Consists of additional info concerning  
the Overpressurization Mitigating System  
for both units of Cook Nuclear Plant....  
notorized 11/18/77....w/att drawings.....

Donald C. Cook Nuclear Plant Units 1 & 2  
Docket Nos. 50-315 & 50-316  
DPR. NO. 58 & CPPR NO. 61.

The purpose of this letter is to provide additional information concerning the Overpressurization Mitigating System for both units of Cook Nuclear Plant.

## FIGURE #1

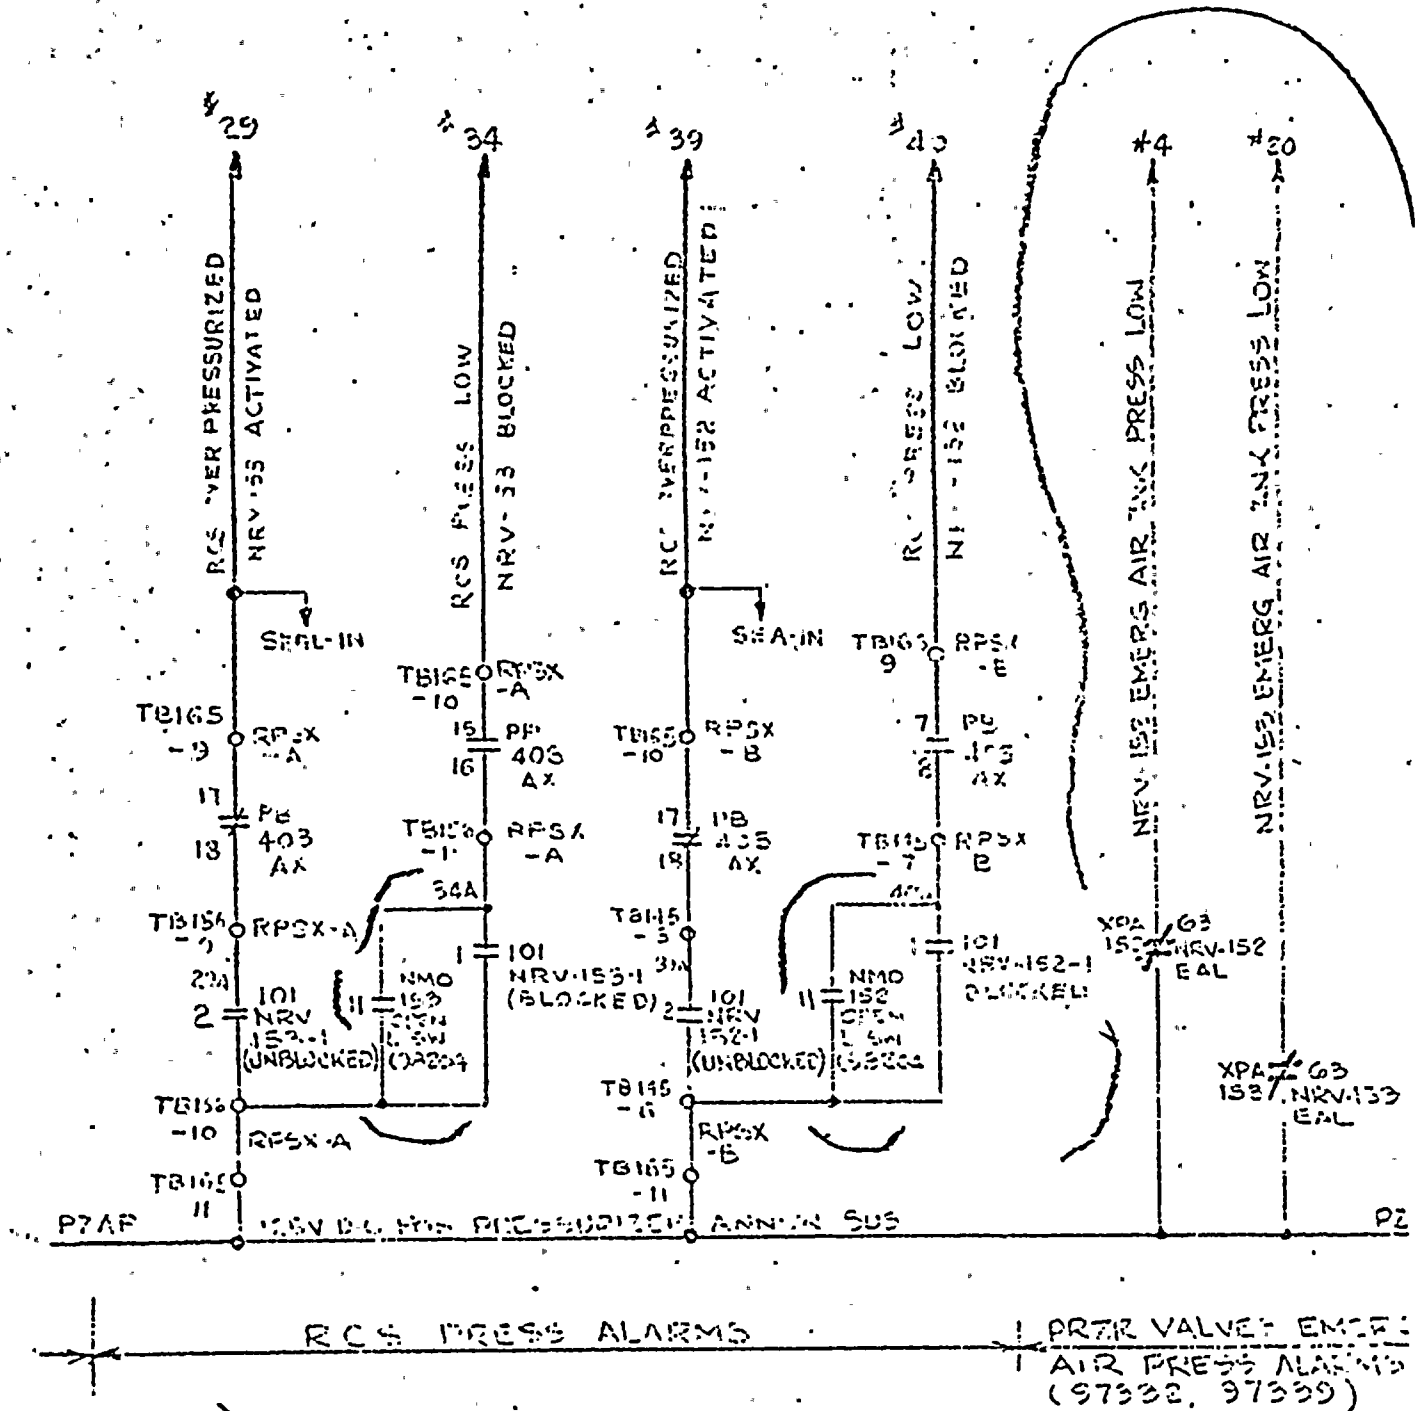
In our letter of August 4, 1977 we indicated, in response to Item No.4, that control room annunciation will be provided for the motor operated valves up-stream of the PORV's to alert the operator if these valves are closed when the mitigating system is enabled. Figure No. 1 provides the revised electrical schematic for the mitigating system annunciators and shows electrical contacts for the "hard-wired" motor operated valve alarms. In addition, this figure shows electrical contacts for a pressure alarm, transmitting to the control room, to alert the operator that the compressed air bottle air pressure is low, as indicated in response to Item 6, of our August 4, 1977 letter. Figure No. 1, is the final version for Overpressurization Mitigating System annunciators and replaces Figure No. 3 of our August 4, 1977 letter.

## FIGURE #2

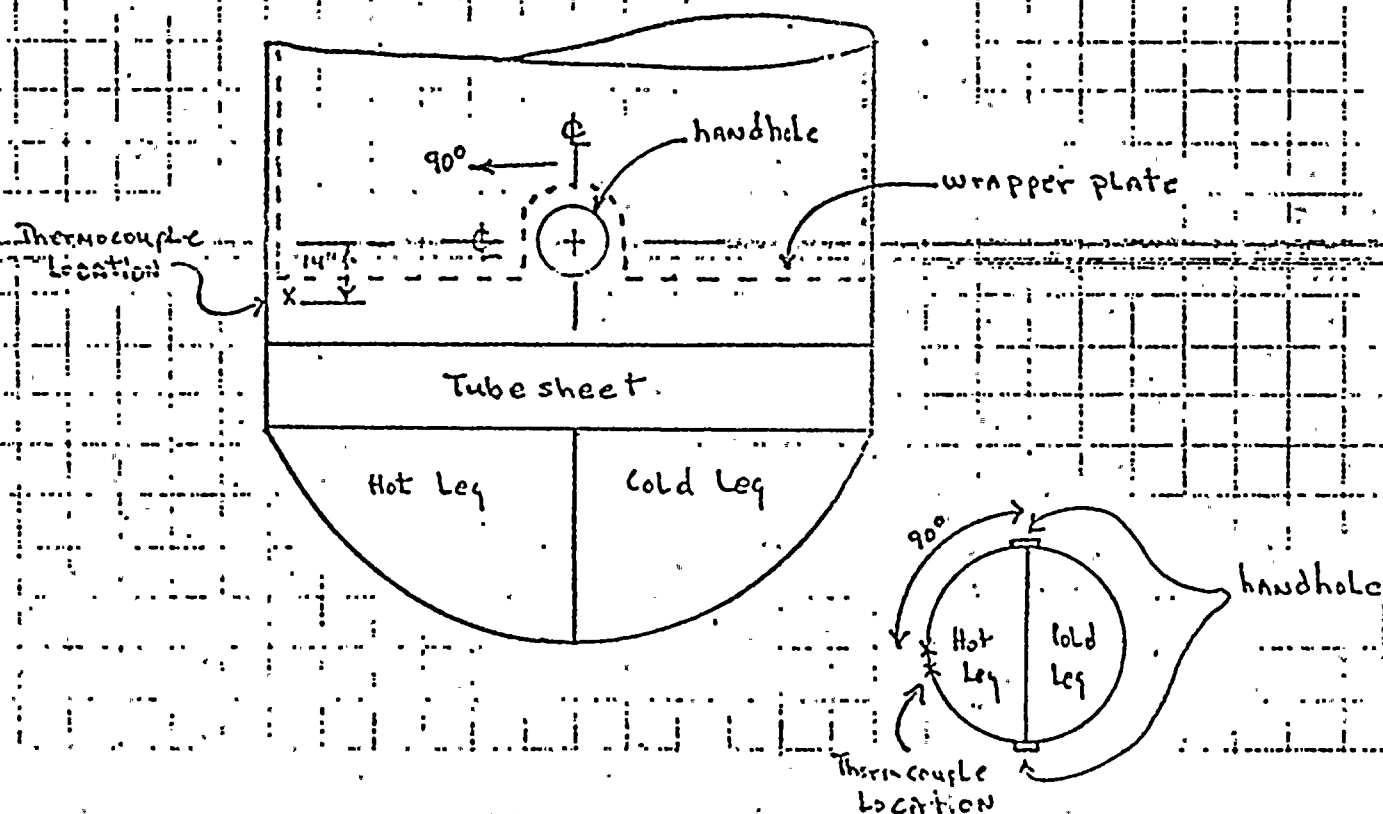
We will be installing surface thermocouples on each steam generator (SG), above the tube sheet, to measure SG shell side temperature. The SG temperature will be shown on a temperature indicator so that the operator can compare SG temperature to the RCS cold leg temperature for the RCS loop in which a Reactor Coolant Pump (RCP) is to be started. Should the SG temperature exceed the RCS temperature by more than 50°F ( $\Delta T$ ) in a loop, the RCP in that loop will not be started up until  $\Delta T$  is brought within limits ( $\Delta T \leq 50^\circ\text{F}$ ). Figure No. 2 shows the thermocouple locations on the SG. In addition, a spare thermocouple will be installed on each SG. We shall include this  $\Delta T$  limit in our proposed technical specifications for Donald C. Cook Unit 2 and propose the same technical specification for Unit 1 so that it can be available by the time of installation of the OMS in Unit 1.

Two (2) thermocouples are to be located 14" down from the centerline of the handhole (secondary side) AND 90° around the circumference of the steam generator handhole on the hot leg side. One thermocouple should be on the 90° azimuth and the other located 4" away on either side.

To determine the hot leg side of the steam generator visually check to see which side the hot leg pipe enters. This should be located between the two handhole plates. Select a hand hole AND measure down 14" from its centerline. Keeping a line of 7" in the same plane locate the first probe 90° away from the handhole on the hot leg side.

Steam Generator Insulation will have to be modified for thermocouple and leads.
